## Environmental Planning Commission

**Agenda Number: 02**  
**Plan #: VA-2025-00114**  
**Hearing Date: September 18, 2025**

### Staff Report

<b>Agent</b>	Jireh Construction
<b>Applicant</b>	Manuel Chacon
<b>Request</b>	Variance – EPC (VPO-2 Height Standards)
<b>Legal Description</b>	Tract 12 Block 10 of Volcano Cliffs Subdivision Unit 22
<b>Location</b>	6304 Petirrojo Rd NW between Vista Del Prado NW and Urraca St. NW
<b>Size</b>	Approximately 0.4 acres
<b>Existing Zoning</b>	R-1D

ELEVATION VIEWS  
HEIGHT VARIANCE

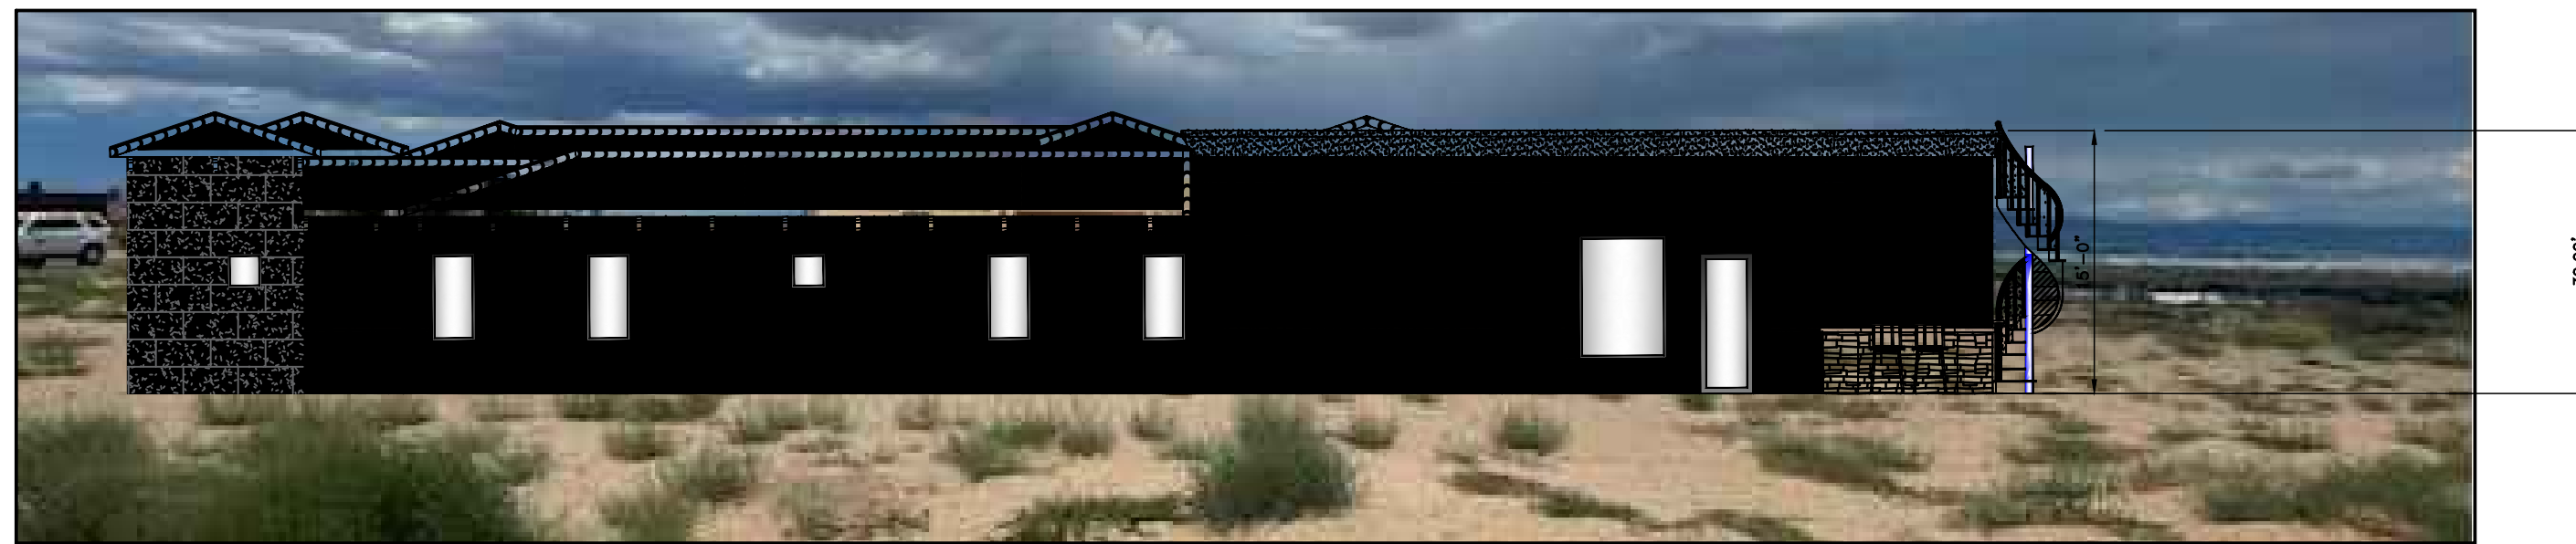
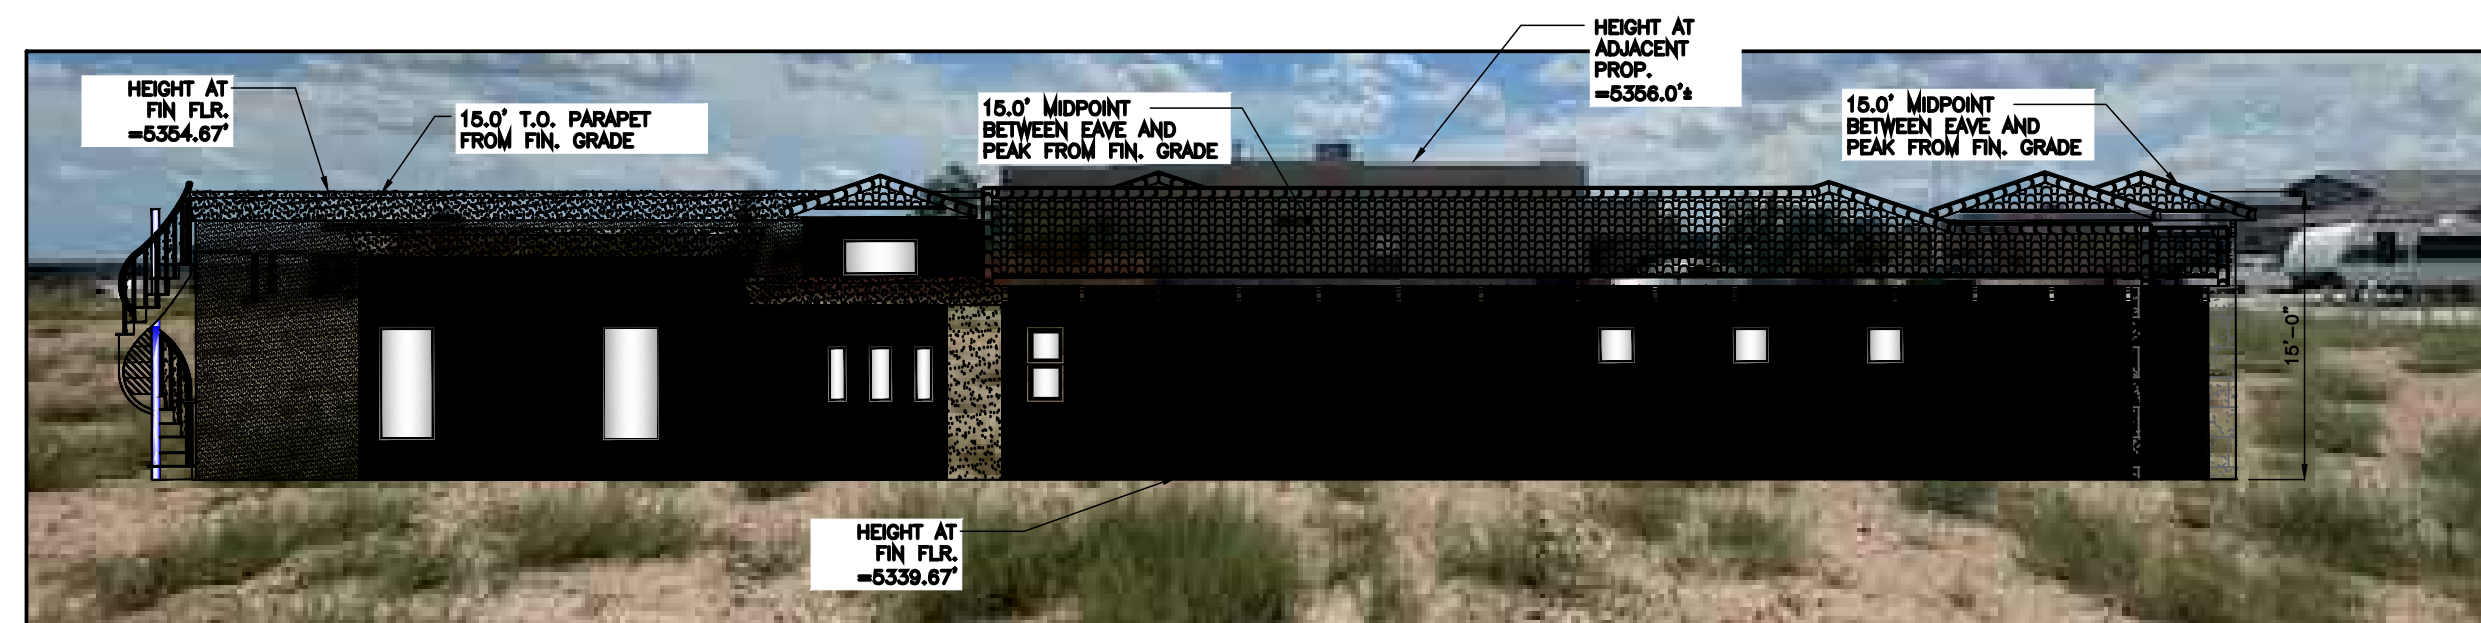
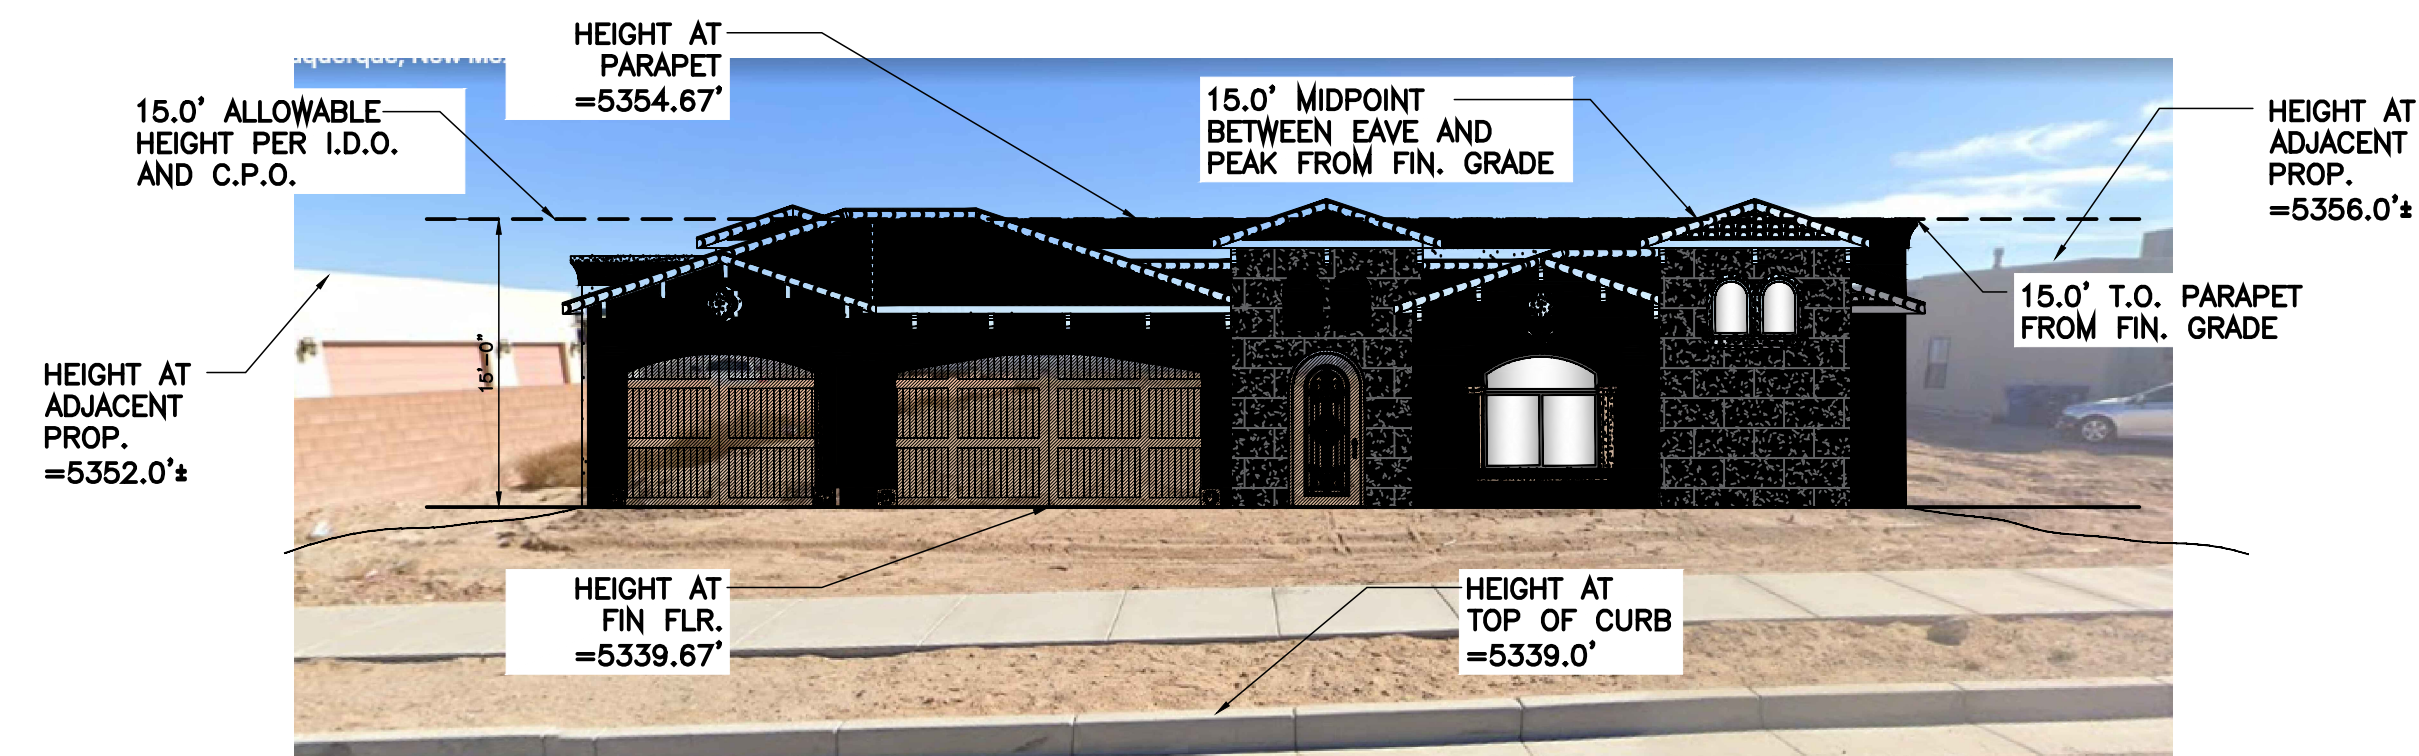
1. Rename sheet to “Elevations Views (Height Variance).” Please rename this sheet on the “Sheet Index.”
2. Remove Site Plan because it is on Sheet 1.
3. Remove Section View Arrows.
4. For views A/2 and B/2 please make the background images more transparent (scale back) to make the line drawings of the elevations easier to see and stand out more.
5. Please add the dimensions and a scale to the elevations.

D  
2 VIEW LOOKING NW FROM VISTA DE PRADO

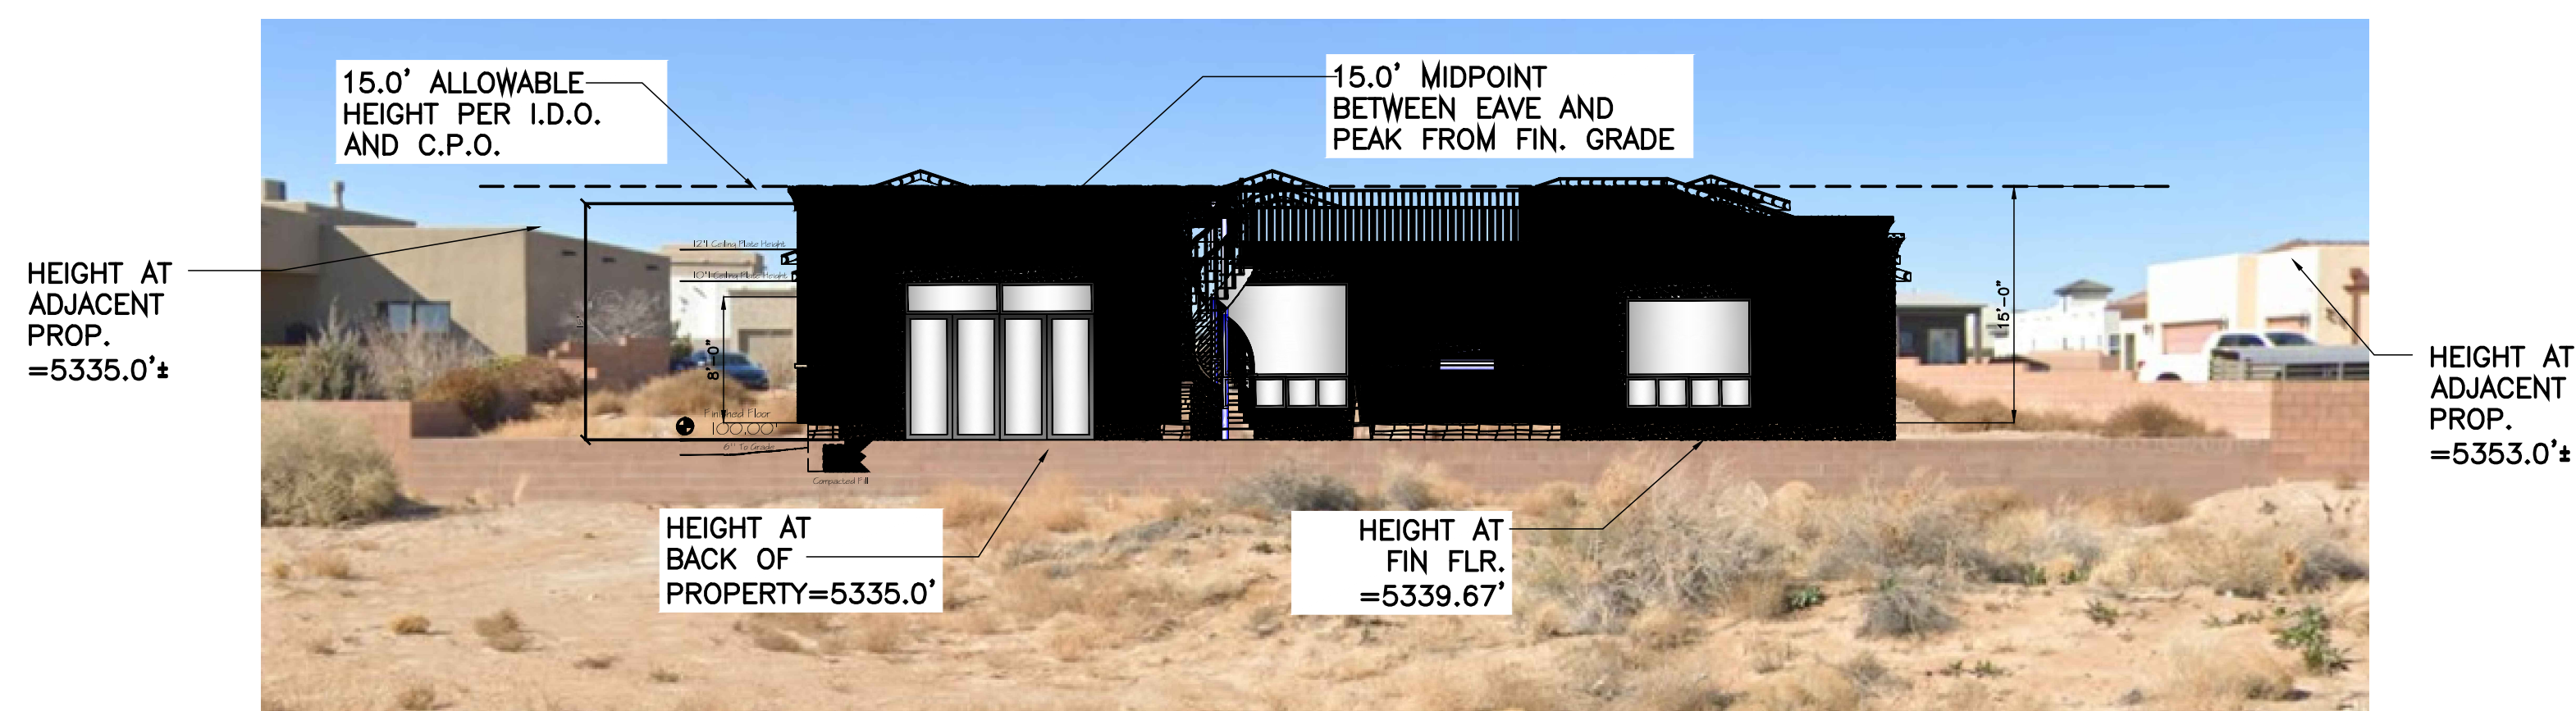
6. Sheet “Elevation Views” shall change from sheet 3 to sheet 2.
  7. Elevation D/2 View Looking NW from Vista Del Prado note “Height at Adjacent Prop =5335.0” pointing to the adjacent building on the left shall be corrected to “5356.0” to match the elevation on C/2 View Looking SE from Petirrojo.
